MEMORANDUM

Subject: Panel No: PPSSNH-59
LDA2020/0044 – 1 Eden Park Drive, Macquarie Park

Figure 1: Pedestrian Pathway (highlighted in red).

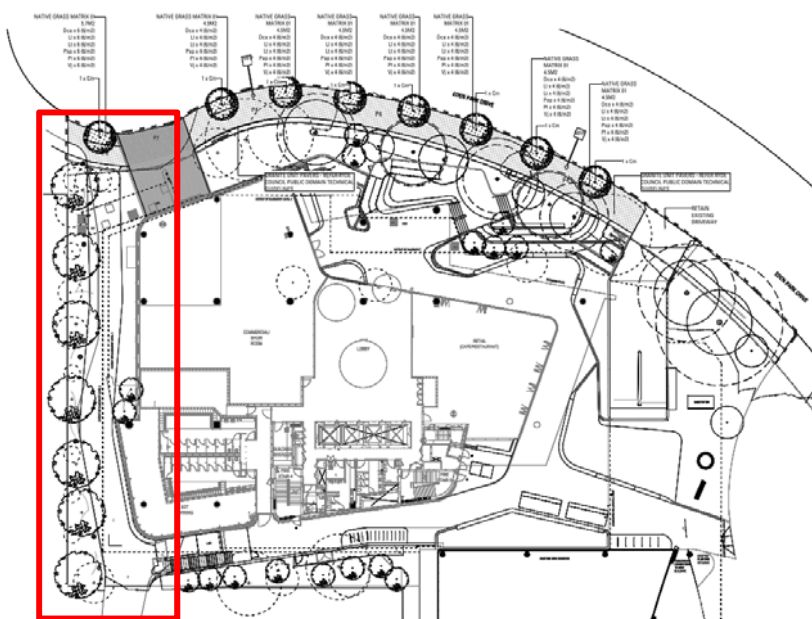
The application proposes the construction of a pedestrian pathway and public access easement as part of the Macquarie Park Access network to provide pedestrian access from Eden Park Drive to Waterloo Road. This pathway runs along the western boundary of the site (See Figure 1).

This pathway will be blocked at the southern end of the site until such time the adjoining allotment to the south is redeveloped.

Informal pathways and landscape elements are designed to clearly define the pedestrian pathway entrance ensuring effective access and way-finding control which will aid to channel the pedestrians into this area. The pathway will be blocked at the southern end until such time the through link is provided, and at which time pedestrians will be channelled though the site via the path as the most efficient means for pedestrians to travel from Eden Park Drive to Waterloo Road.

During the assessment of the application, refinements to the design of the proposed pedestrian link was requested to address safety issues, with a recommendation that the Ground Floor plan should be reconfigured to increase passive surveillance to the western boundary.

In response, the applicant altered the pedestrian pathway to provide a more direct line of sight from Eden Park Drive down the pedestrian link, to the southern boundary through changes to landscaping and the path layout. The applicant also reconfigured the end of trip area to run through to the north facing window which overlooks the pedestrian link and submerged the plantroom into the floor plate, increasing passive surveillance to the proposed pedestrian link from the north-facing windows.
